MODIFICATION REQUEST:

120-128 Herring Road, Macquarie Park

***MP09_0195 MOD 4 – Modifications to
Building E - floor levels of lobby entrance /
car park and landscaping***

Director-General's
Environmental Assessment Report
Section 75W of the
Environmental Planning and Assessment Act 1979
November 2013

Figure 4: Proposed Urban Form Control Diagram (Plan)

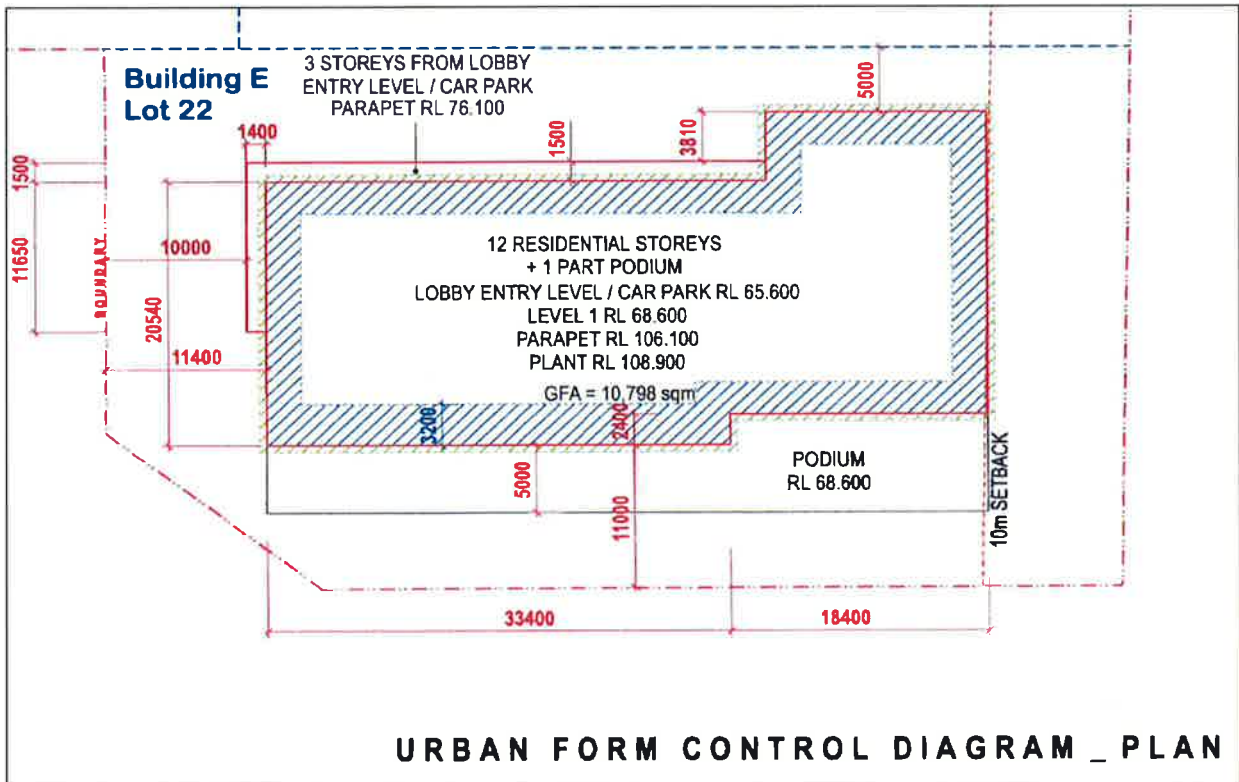
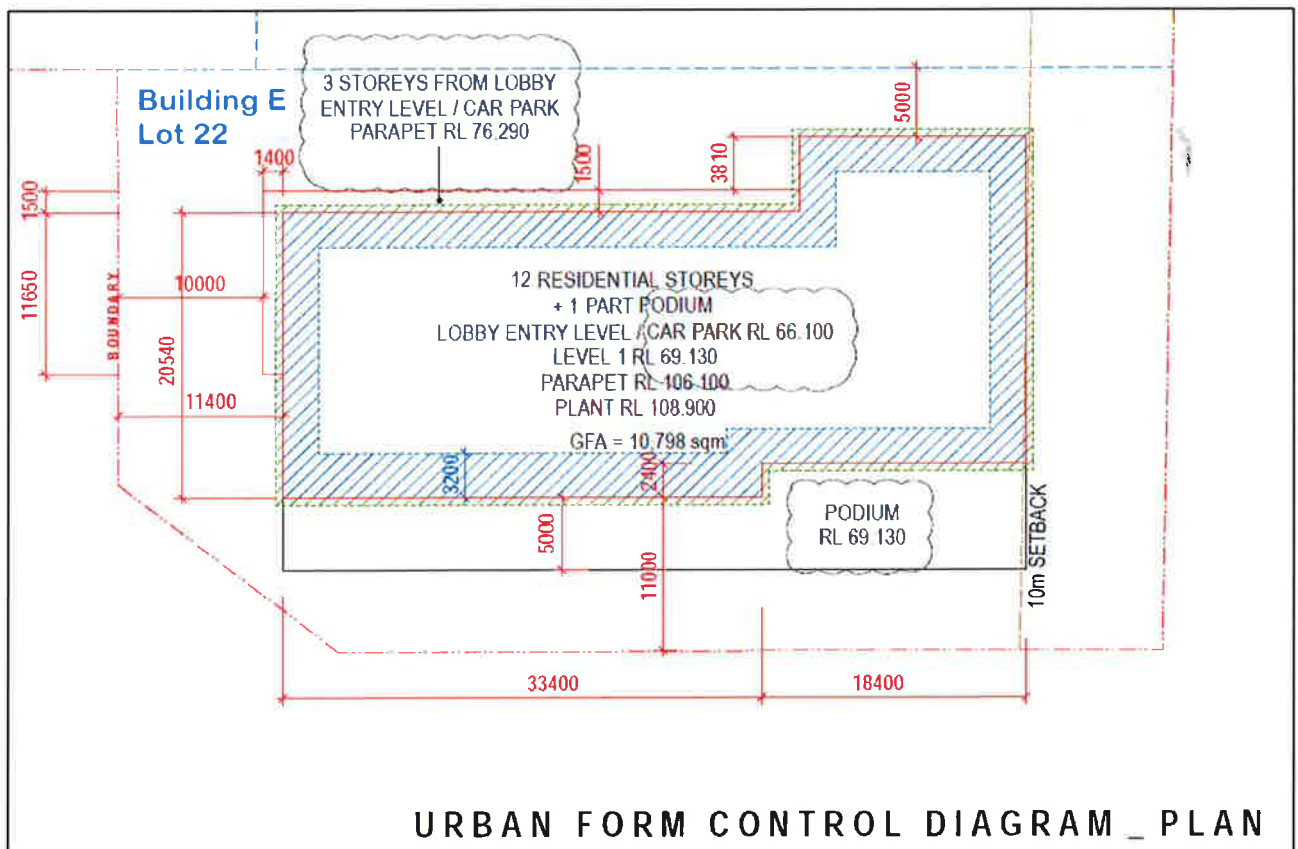
1. Raise the floor level of the lobby entry / car park level of Building E by 0.5 metres to accommodate overland flow. This would have the consequential effect of raising all the levels above ground floor. The increase in levels can be accommodated within the approved envelope and as such it is not proposed to increase the overall height of Building E;
2. Remove five trees (Nos 26 and 30-33 on the Tree Management Plan) to allow remediation works, accommodate a substation, and to address safety concerns. The five trees to be removed are proposed to be replaced by five trees of the same or another suitable species; and
3. Remove the asbestos currently located within the landscaping mound. It is proposed to remove the mound to allow remediation works. Additional landscaping is proposed to replace the mound to soften the appearance of the building within the streetscape.

- **Condition A2** - Replacement of drawing A161 Urban Form Control Diagram Rev L with Rev M (Refer to **Figure 4** below);
- **Condition A2** - Replacement of drawing A162 Urban Form Control Diagram Elevation Along Herring Road Rev I with Revision J (Refer to **Figure 6** below); and
- **Condition A2** - Replacement of drawing LP-3 Tree Management Plan Rev E with Rev I (Refer to **Figure 7** below).

Figure 6: Proposed Urban Form Control Diagram (South Elevation)

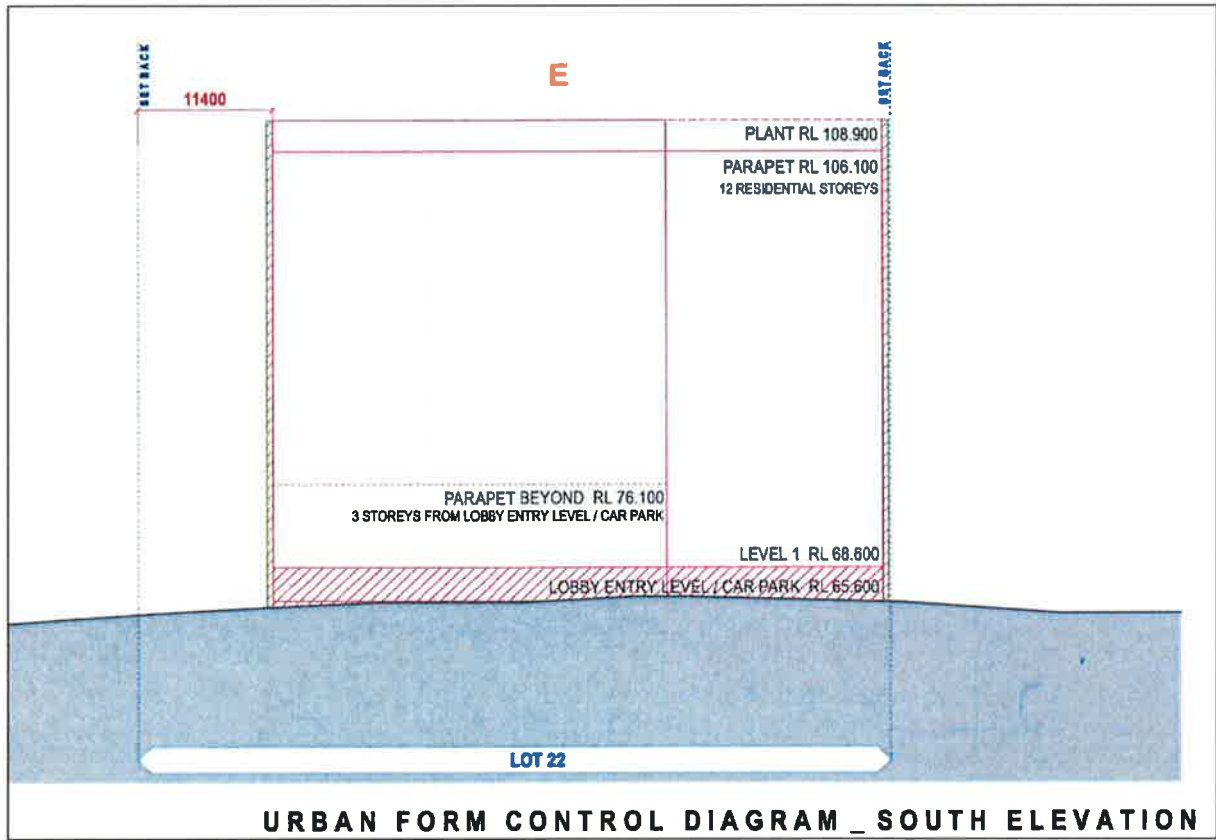
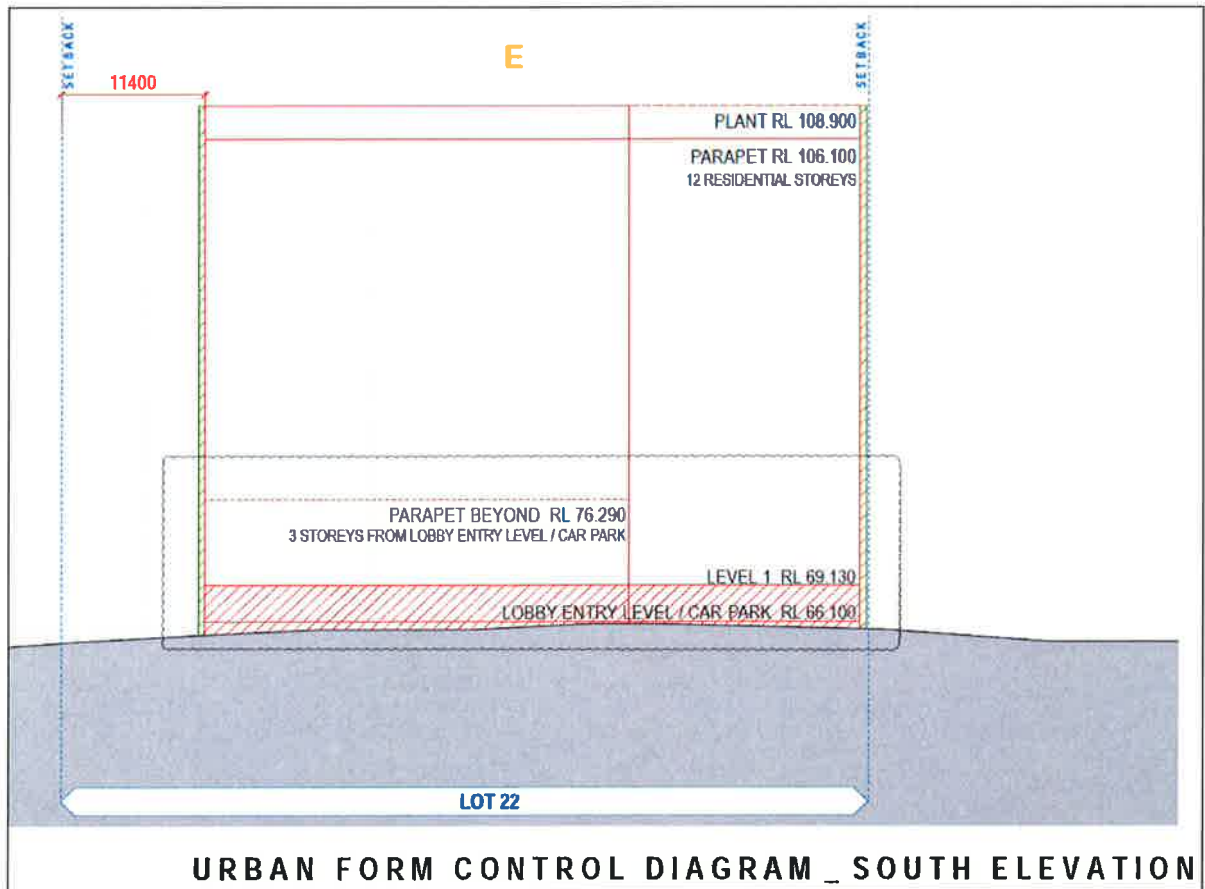
The proposed increase in ground floor levels would not result in an increase in the approved maximum height of Building E, as the consequent increase in height to levels above would be accommodated within a redesigned roof space. The 0.5 metre increase in the ground level of the lobby entry level/car park level will result in the following changes to the levels of Building E:

Figure 7: Additional Trees Proposed for Removal (see below for detail of red bordered insets)

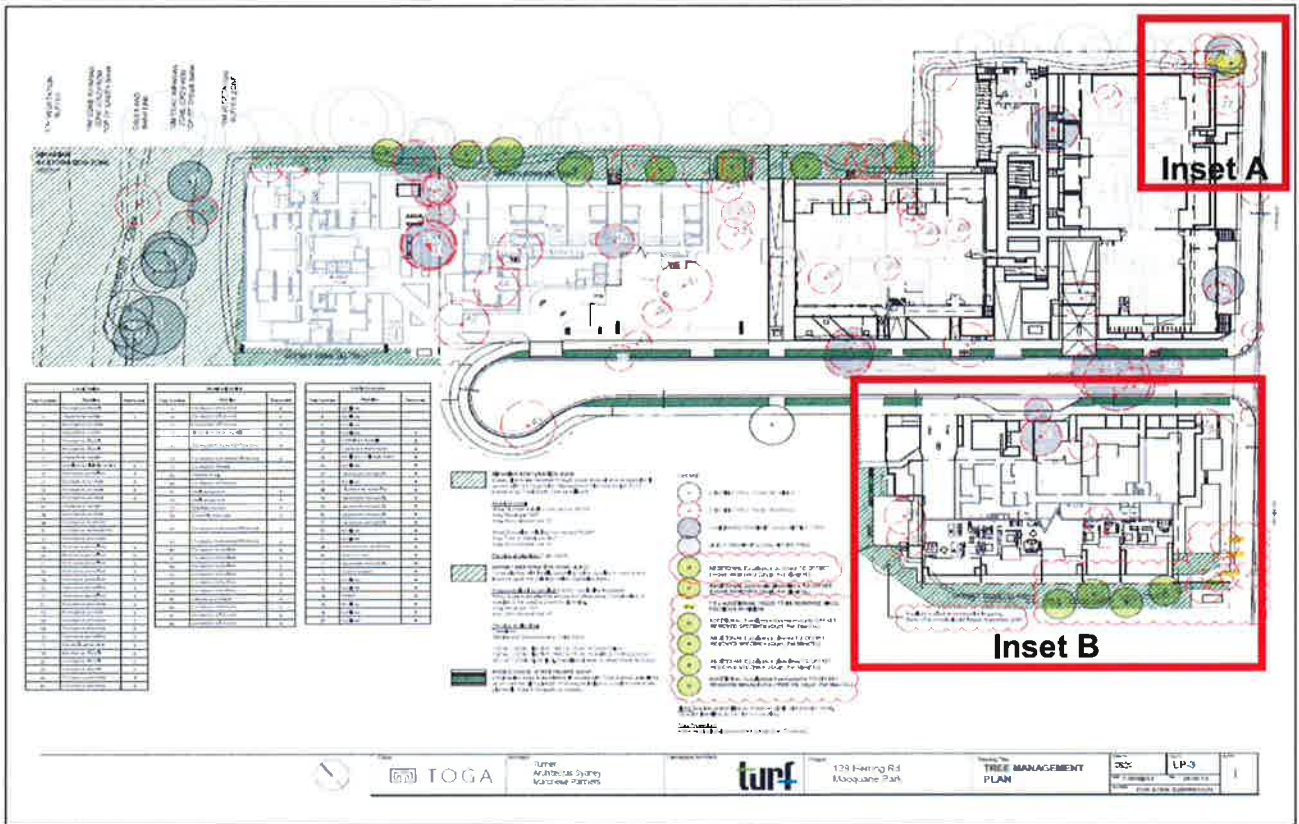
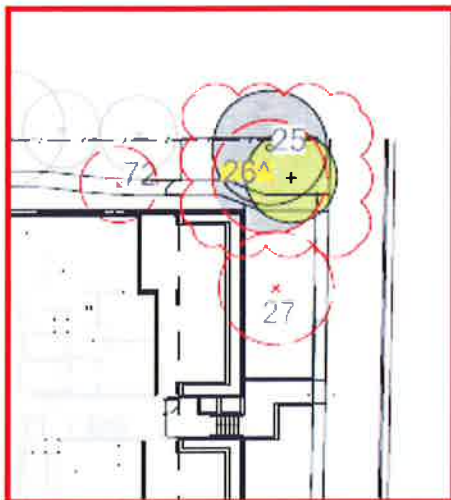
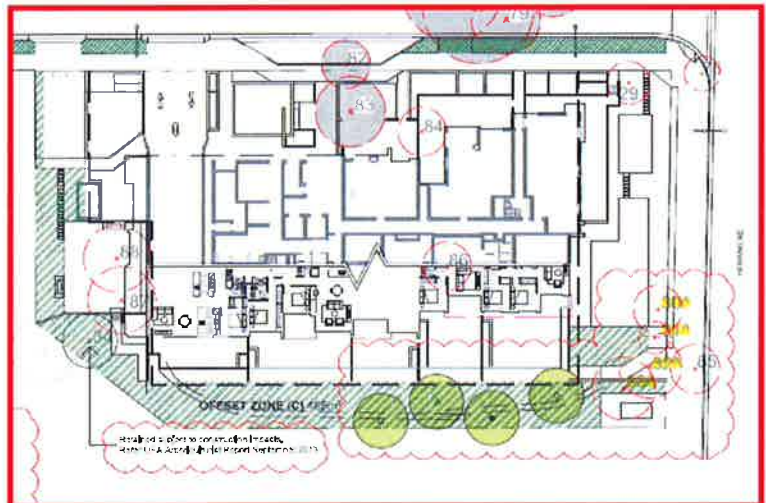
- Trees 30 and 31 - are required to be removed due to the need to remediate the soil they sit within due to soil contamination and because of the proximity to the existing landscaped soil mound which is proposed to be excavated and removed;
- Tree 32 – required to be removed due to risk and safety issues. The arboricultural assessment indicates that this tree suffers from an extensive stem cavity and decay and should be removed due to the risk to property damage and personal injury should it collapse;
- Tree 33 – required to be removed to accommodate an electrical substation; and
- Tree 26 - adjacent to Building A is dead and required to be removed to address risk and safety issues. The Council has issued an approval to remove this tree prior to this application because it represented a risk to public safety.

The Tree Management Plan (**Refer to Figure 7**) has been amended to reflect those trees that are proposed to be removed as part of this Section 75W Modification and includes the planting of five additional offset trees as follows:

The Department has reviewed the proponent's Arboricultural assessment and agrees that it is appropriate to remove the additional trees. The modified Tree Management Plan would result in a similar level of landscaping and streetscape appearance as approved. The identified basis for the removal of trees is considered to be reasonable and necessary. Accordingly, the Department recommends that **Condition A2** be amended to reflect the revisions to the approved Tree Management Plan.

Figure 8: Relationship of road, footpath and proposed level of building lobby.

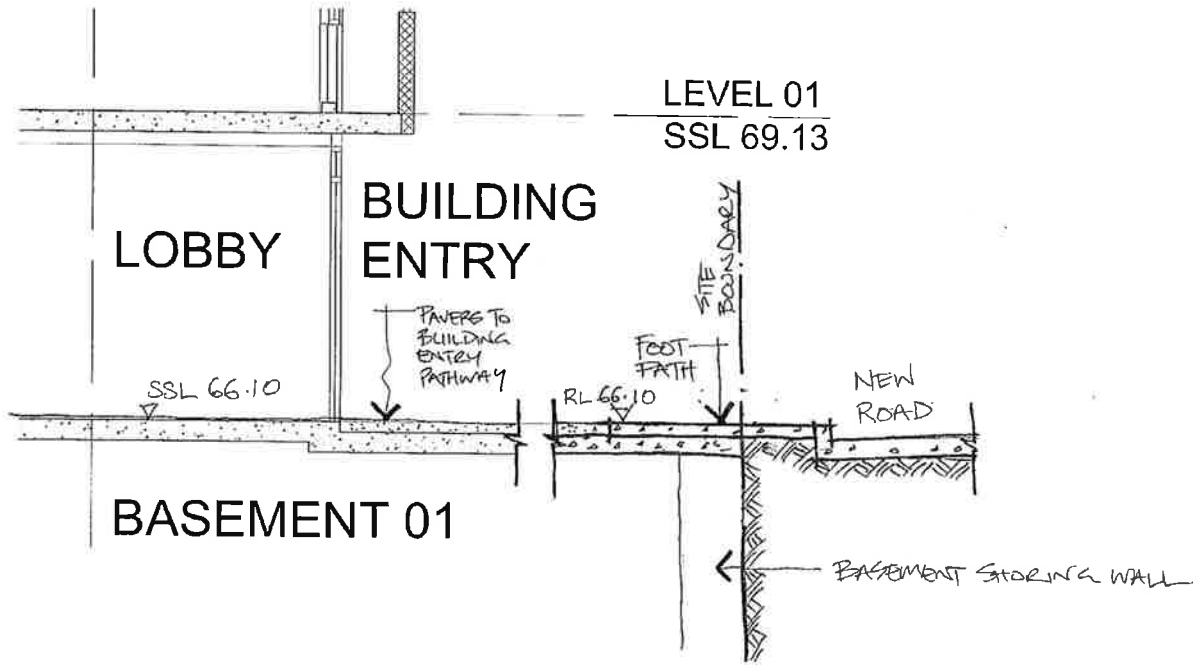
The modification seeks approval to raise the floor level of the lobby entry / car park level of Building E by 0.5 metres, from RL 65.6 to RL 66.1. The proposed modifications are necessary to address stormwater runoff associated with the increased level of the new internal road (LDA2012/114) and to provide the required 300 mm floor level clearance above the 1:100 flood level for stormwater runoff in accordance with the requirements of Ryde City Council.

Currently, the approved building falls from the footpath to the foyer and courtyard areas. Further investigation has identified that surface stormwater runoff from the road and footpath would likely cause local inundation or flooding of the building during a rainfall event. By raising the building floor level by 0.5 metres the courtyards could then be graded away from the building entry points so that surface water will not enter the building. The proposed floor level would also protect the building from potential flooding impacts even if the stormwater surface grates happen to become blocked during a rainfall event.

The approved (RL 65.60) and proposed lobby entry level (RL 66.10) for Building E is above the 1:100 flood clearance level. The proposed increase in the level of the lobby entry is therefore not driven by any flood levels associated with the creek.

The Department supports the proposed increase to the lobby entry level and car park floor levels of Building E as it will address Council's overland flow floor level requirements. The proposed increase in floor levels will not result in changes to the approved envelope of Building E and would not have any perceptible impact on the approved height or bulk and scale of the building. Further,

Figure 9: Approved South East Elevation to Herring Road, showing the landscaped mound

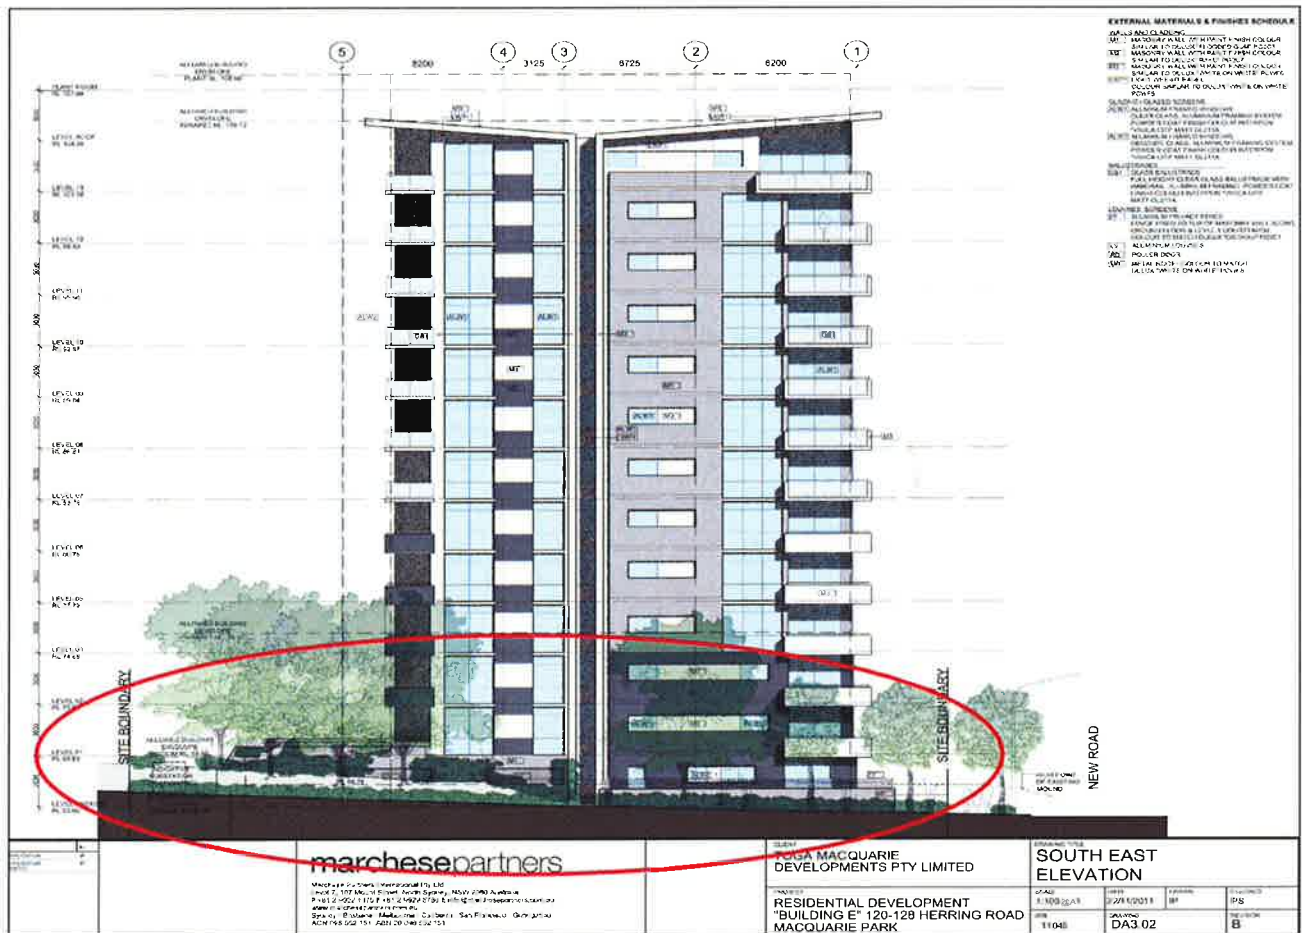
The existing earth mound on the Herring Road elevation is contaminated with asbestos, and was recommended to be removed in the Phase 1 contamination investigation, exhibited with the Concept Plan. However, the existing earth mound assists in softening the streetscape appearance of Building E, as seen from Herring Road, and this is evident from the approved South East elevation depicted in **Figure 9**, below.

Ryde City Council's Assessment Report for the construction of Building E (Ref: JRP No. 2012SYE089 – DA No. LDA 2012/0314) to the Sydney East Region Joint Regional Planning Panel indicates that the Urban Design Review Panel (UDRP) had concerns over the ground floor streetscape interface of the building with Herring Road that would result from "50% of the street facade being dominated by an approximately 3 m high wall to the car park." However, Council's report acknowledges that the UDRP had not considered the proponent's landscaping plans and that, "these plans show the retention of the mound within part of the front setback area". The report outlines that the existing earth mound, together with proposed landscaping would result in a satisfactory streetscape appearance, and that this is demonstrated by the proposed Herring Road elevation which accompanied the application to Council. This same Herring Road elevation is depicted in **Figure 9** of this report.

It is acknowledged that the requirement to remediate the site and remove asbestos contamination from the existing earth mound is necessary. However, given the superior streetscape outcome which would result from retention of the mound, it is recommended that the mound be removed, remediated and reinstated.

Accordingly, a suitable condition has been incorporated into to the recommended modifying instrument to require the mound to be reinstated and landscaped, following remediation. Future development applications are required to address remediation of the mound in accordance with the Concept Plan approval.

Figure 11: Detail Section of the proposed elevation to Herring Road, showing additional landscaping to compensate for the removal of the mound. The landscaping within the red oval is 'screening' a 3-4 metres high blank expanse of wall.

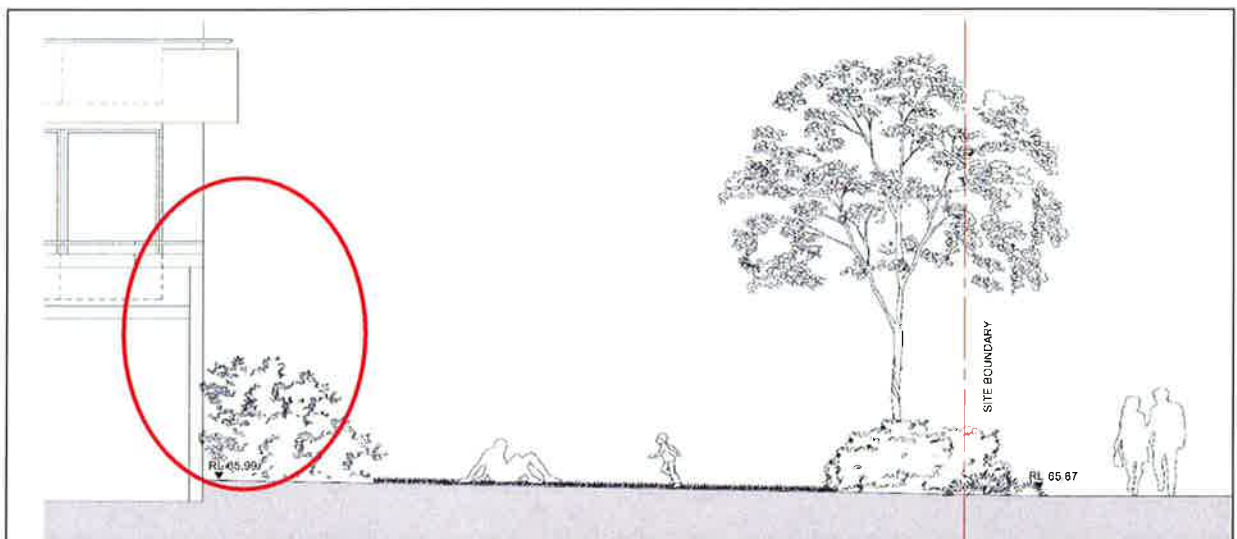
Figure 11 indicates that the additional landscaping to compensate for the proposed removal of the existing mound would serve to screen an otherwise blank expanse of podium wall on the Herring Road streetscape elevation. It is the Department's view that the approved streetscape presentation of Building E is superior to the modified Herring Road streetscape elevation, following the removal of the mound. Also, given that Council's report to the JRPP relied upon retention of the existing landscaped mound to mitigate the impacts to the Herring Road streetscape that would otherwise occur from blank expanse of a 3 metre high wall, it is the Department's view that reinstatement of the existing mound is considered necessary to achieve a satisfactory Herring Road streetscape interface.
